Details for: **BROD.0074**

Thank you for considering Brodogradnja. Please see the comments of the reviewers on the revised manuscript Influence of the Canal Width and Depth on The Resistance of 750 DWT Perintis Ship Using Computational Fluid Dynamic (CFD) Simulation. I suggest you consider these comments, suggestions and questions and revise your article accordingly. For your guidance, reviewers' comments are appended below. If you decide to revise the article, please submit a list of changes or a rebuttal against each point which is being raised when you submit the revised manuscript.

Thank you for giving me the opportunity to submit a revised draft of my manuscript entitled "*Influence of the Canal Width and Depth on The Resistance of 750 DWT Perintis Ship Using Computational Fluid Dynamic (CFD) Simulation*" by Eko Sasmito Hadi, Tuswan Tuswan, Ghina Azizah, Baharuddin Ali, Muhammad Luqman Hakim, Muhammad Raafli Caesar Putra Hadi, Muhammad Iqbal, Dian Purnamasari, Dendy Satrio for consideration for publication in the Brodogradnja/ Shipbuilding. We appreciate the time and effort you and the reviewers have dedicated to providing your valuable feedback on my manuscript. We are grat

Fig. 2 750 DWT Perintis Ship lines plan.

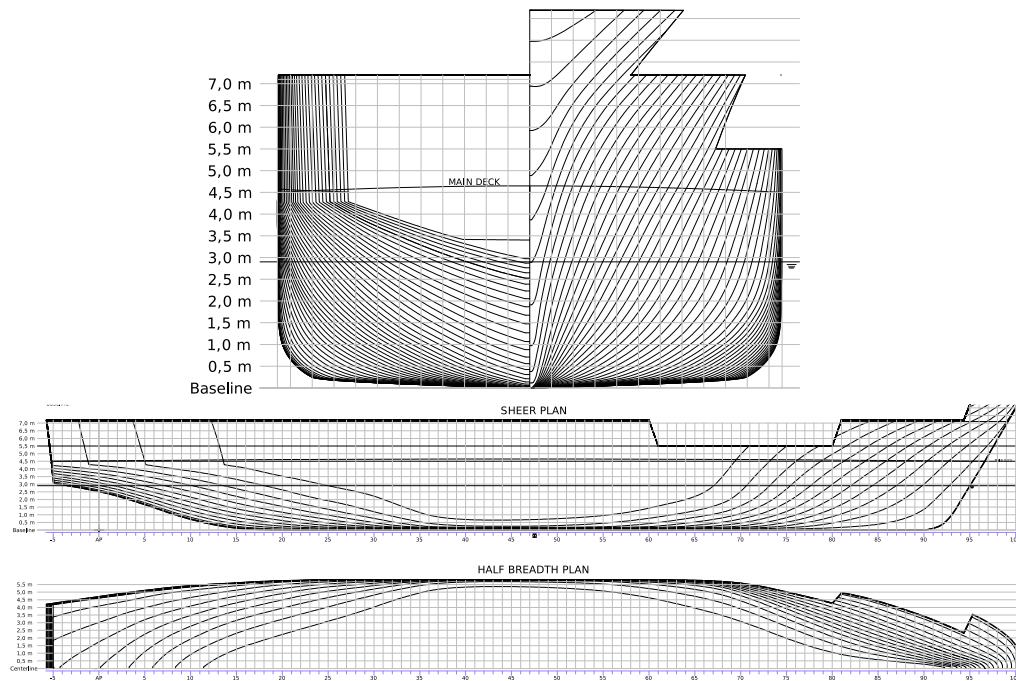
1. Fig 1 does not contribute to depicting the hull form. Fig 2 should be kept, but "body plan" should be larger, as it is the main information to reproduce the model and results.

Answer: Thank you for the recommendation. We agree with your suggestion. We have revised Figure 2 with larger view of body plan. The revised Figure 2 is as follows:

Fig. 10 y^+ contour on the Perintis 750 DWT ship hull in the range of (0–90).

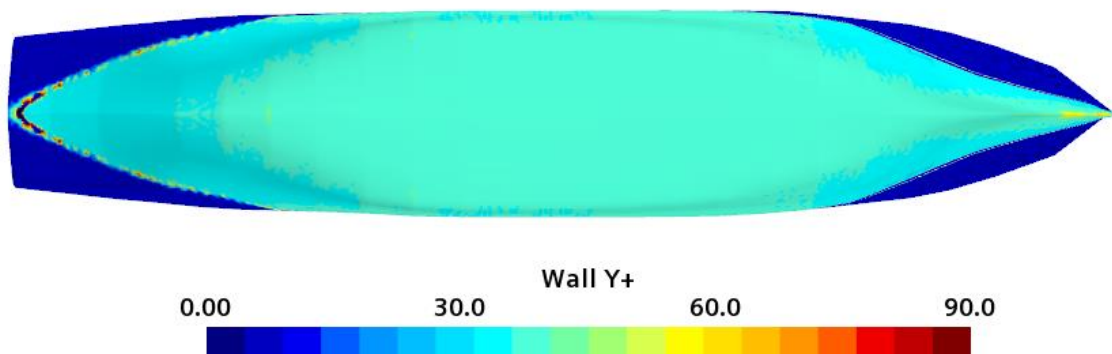
7. Y^+ is dangerously close to the transitional range, how do authors explain this?

9. The validation underpredicts the experimental results for Froude numbers in which wavemaking is important. It means that your wavemaking procedure is not converging well enough. Fig 10. also brings up this uncertainty, since you can see the coarse wetted regions. For this reason, explaining point 8 is even more important!

Answer: We thank for your suggestion. The figure has been revised as also suggested by reviewer 2 to change the upper/lower limits of the colour map and change the colour map style as follows:

Answer: We have explained the validation in more detail. We assume the total resistance is the sum of tangential and normal components. In multiphase simulations, RANS solvers compute the total as $C_T = C_P + C_F$, where C_P is the pressure resistance. Shear drag is the tangential vector component of the total surface frictional resistance of the ship to the fluid. Meanwhile, pressure drag is the normal resistance or drag due to pressure which consists of waves and viscous pressure. Pressure and shear forces all components are interrelated and calculating each presents its own challenges, however exceedingly challenging to divide. We also have changed y+ contour in Figure 10.

Fig. 20 Velocity distribution at Fr 0.35, the blue surface in each plot represents the free water surface : (a) Case V, (b) Case VIII.

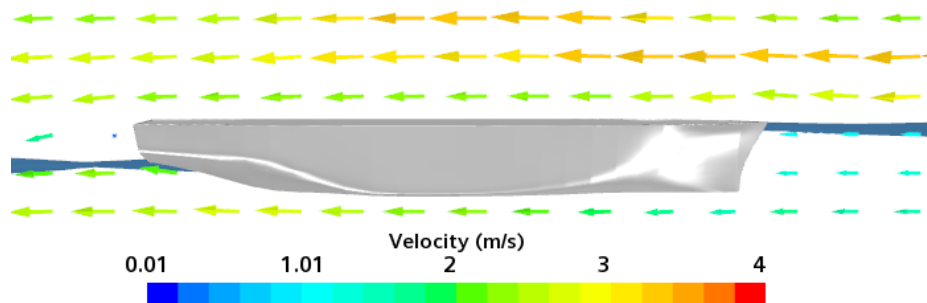
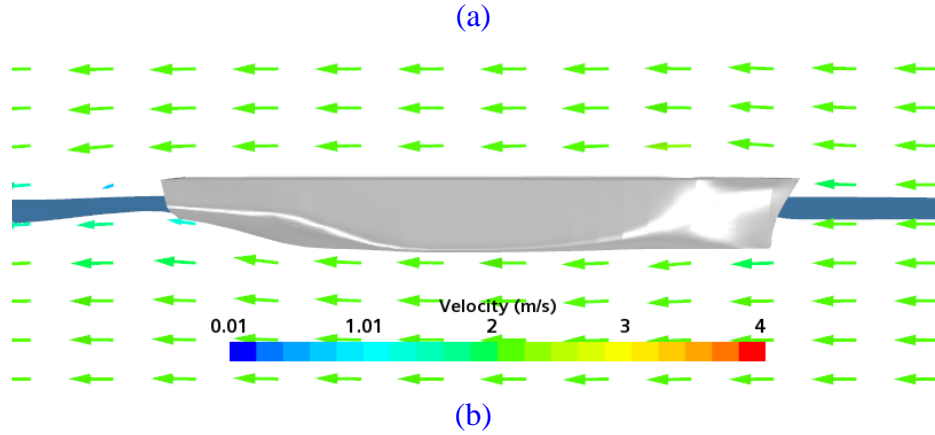
12. The authors should shown how the dynamic pressure field is changing based on the closeness of the bottom in more detail. The image of velocity Fig 20, is not important. Rather, X-Z plane centreplane cut showing dynamic pressure for various depths should be shown. This is the real information on why wavemaking changes, and the resistance force!

Answer: Thank you for your good idea. The changes are highlighted in blue font colour.

The flow velocity distribution is shown in Fig. 20

Fig. 21 Pressure distribution in all cases at $Fr = 0.35$.

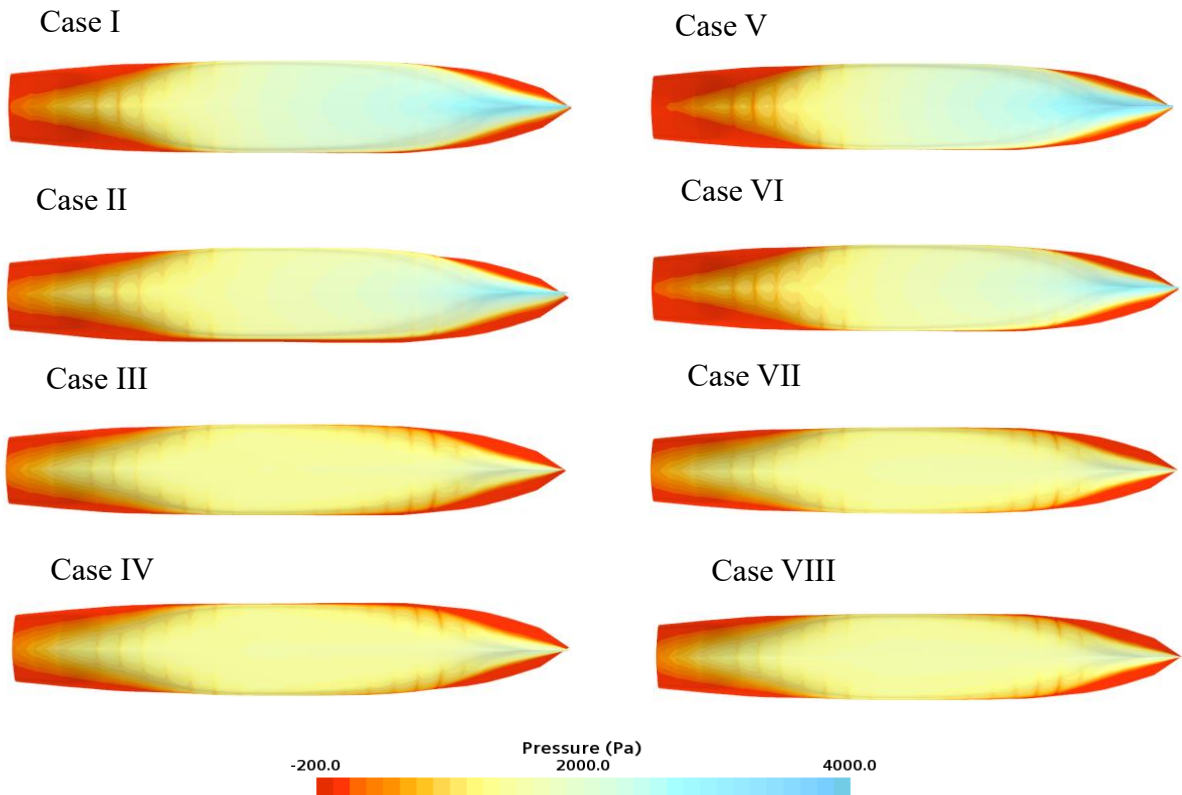
13. Please describe physically what happens with help of point 12, as well as your other results, instead of simply comparing the numbers and leaving the rest to readers.

The pressure distributions for all cases are shown in Fig. 21. The results demonstrate that the pressure distribution around the ship model is more uniform in the case of $hw/T = 16.15$. However, in the case of $hw/T = 2.24$, it is seen that a significant high-pressure region is formed at the bow. This observation also explains that pressure increase occurs at low ship-to-bank distances. Relatively heterogeneous pressure contours characterize the pressure variations for narrow and shallow channels. The heterogeneity of the pressure contour is achieved at the bow due to the pressure accumulation of fluid caused by the ship entering a narrow and shallow region. For the keel to stern region, the pressure decreases due to the increase in fluid velocity under the keel. This causes the increase of ship resistance in shallow and narrow channels compared to wide and deep channels, leading to the wave pattern change. Based on these results, the bow is a sensitive area where a significant increase in pressure is identified.

Answer: we have described physically Figures 20 and 21 in the text.

Fig. 24 Wave pattern at $h_w/T = 2.24$ and Fr 0.35: (a) $W_b = 2.4$ m (Case I), (b) $W_b = 4.8$ m (Case II).

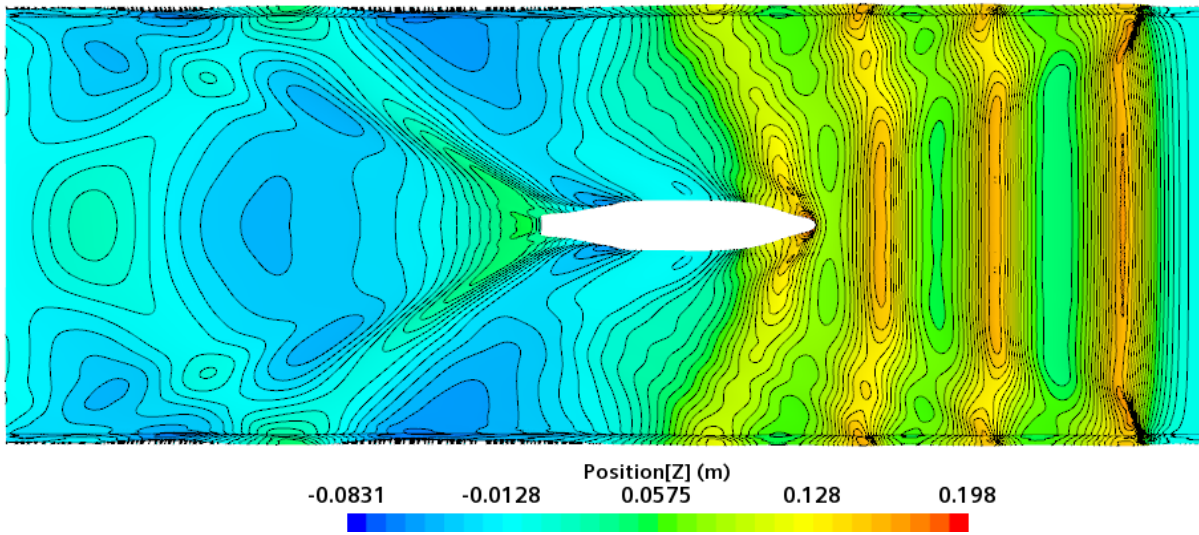
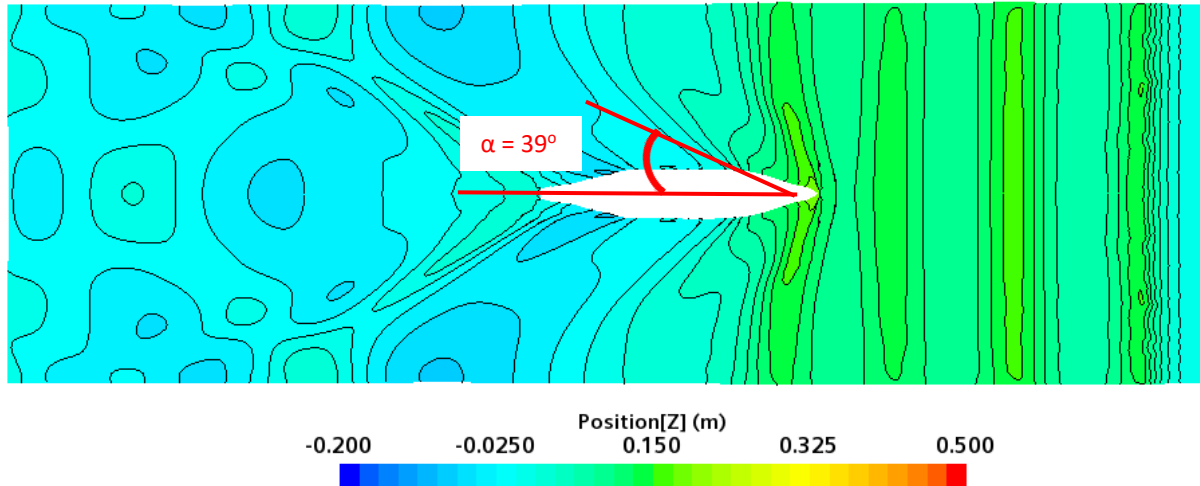
15. Fig 24. also denotes there may be (surely there is) an issue with overset grid interpolation. please see the corners and comment on this.

Answer: Fig 24 and Fig 25. has been revised as follows :

Fig. 10 y^+ contour on the Perintis 750 DWT ship hull in the range of (0–90)

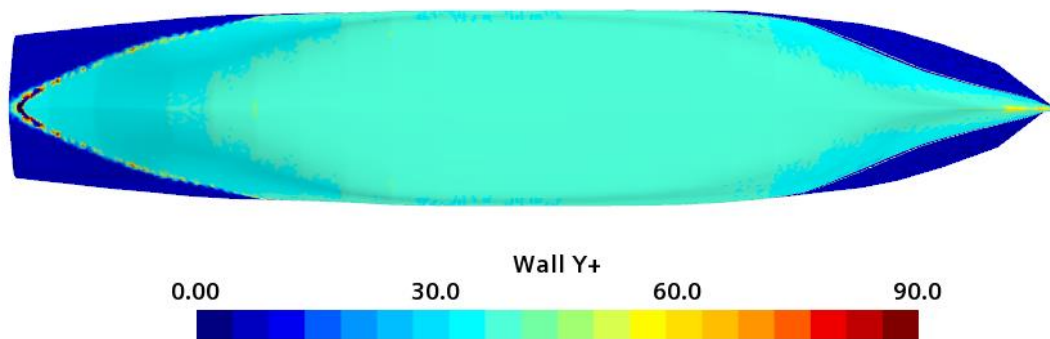
3. Fig. 10. With the current colour bar range, it is not easy to see whether the hull wetted areas have proper wall y^+ values (i.e. $y^+ > 30$). I suggest the authors either change the upper/lower limits of the colour map, or change the colour map style to solve this issue.

Answer: Thank you for the suggestion. We have revised wall y^+ in the range of 0-90. The figure has been revised as follows:

Fig. 22. Water surface x-axial velocity distribution at $Fr=0.35$: a) Case I b) Case IV

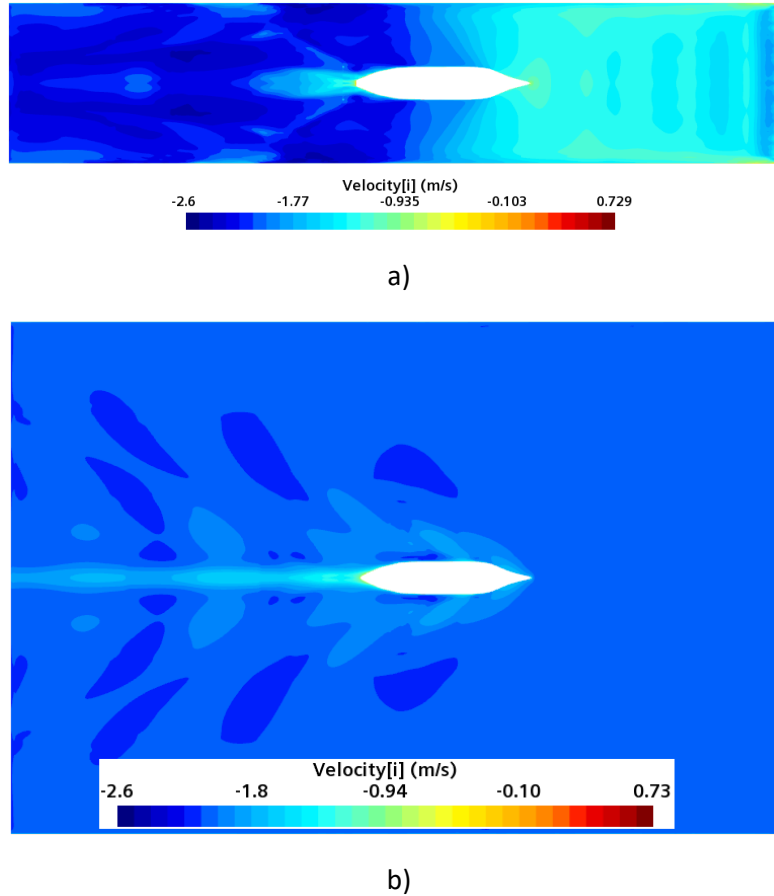
4. Boundary condition (Fig. 5-7) I can see that you used Velocity inlet for the bottoms of the tanks, while using no-slip wall for the sides. Do you have any specific reasons? Especially for the canal simulations, I think No-slip wall with velocity (i.e. moving wall) boundary condition might be a better choice. Also, you did not mention whether you applied any velocity for the no-slip wall for the side of the canal. If you did not apply the velocity on the no-slip wall for the sides (to make it a moving wall), the simulation will not represent correctly the flow around the ship and canal walls. To confirm this, can you please show me the velocity contour around the hull including the reason near the side walls?

Answer: Thanks for the suggestion. We have added the speed contour. The additional figure is as follow:

Fig. 22 shows that when the ship-bank distance or the water depth reduces, the flow stagnation point on the bow deflects the flow towards the canal wall so that the flow on the side of the ship is significantly accelerated. Further, the flow is directed downward, causing the under-keel flow to accelerate.

Fig. 13 Resistance value (RT) versus Froude Number (Fr) and depth Froude Number (Frh) in canal bank (Cases I-IV).

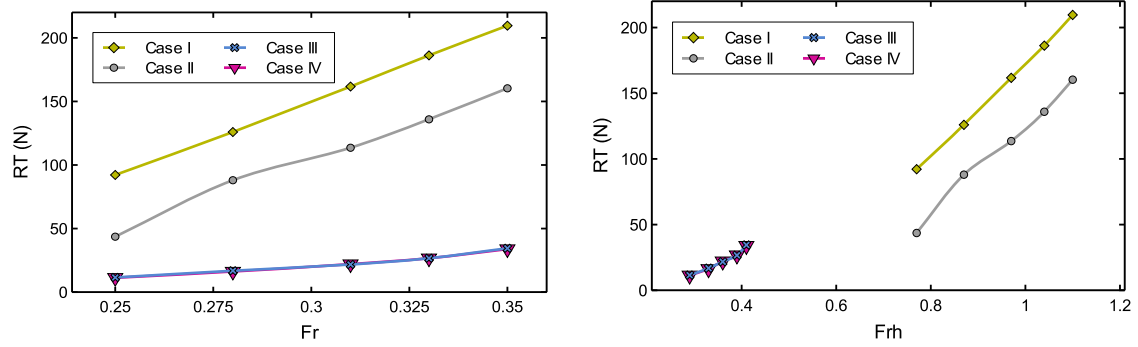
5. Fig. 13 Please check with the caption of Fig. 13. I think “Cases I-IV” & “canal bank” should be correct.

6. Results (Fig. 13-18) Now the results are plotted against the Froude number based on the ship length. I think plotting the results with depth Froude number might be beneficial. Please consider plotting the results with depth Froude number too (maybe you can use 3D figures for both axes, i.e. normal Fr and depth Fr).

Answer: We have corrected the image caption as follows [Fig. 13 Resistance value \(\$RT\$ \) in canal bank \(Cases I-IV\)](#).

Answer: Thank you for the suggestion. We have decided to compare length Froude number and depth Froude number using two figures. The figure has been revised as follows :

Fig. 20 Velocity distribution at Fr 0.35, the blue surface in each plot represents the free water surface : (a) Case V,
(b) Case VIII.

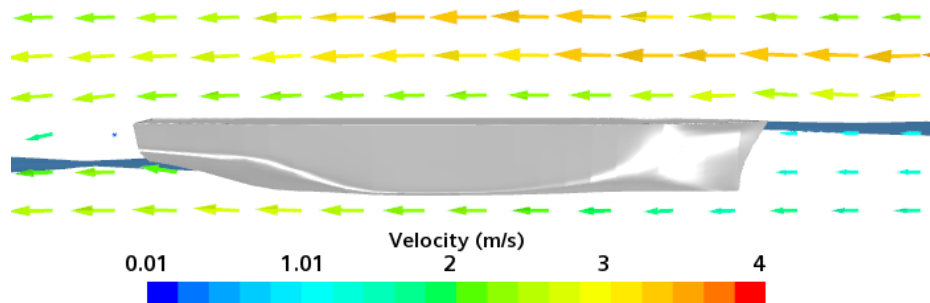
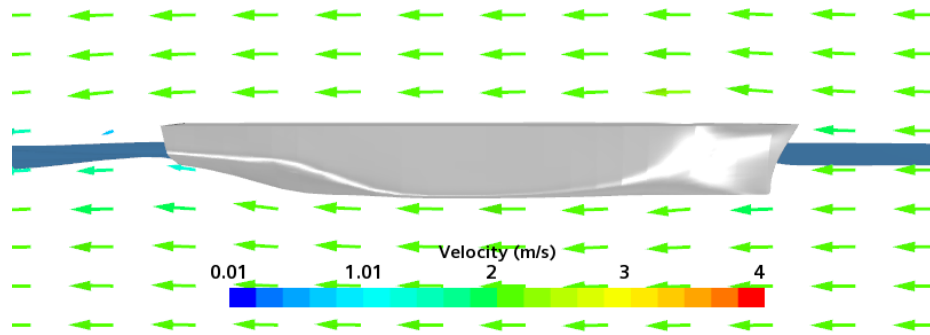
7. Fig. 20. I am sure that you can change the spacing of the vector arrows. Now the arrows are located at their cell centres, but you can change it to uniform spacing. I am sure that the figure will look much better by doing so.

Answer: Thank you for the suggestion. The figure has been revised as follows :
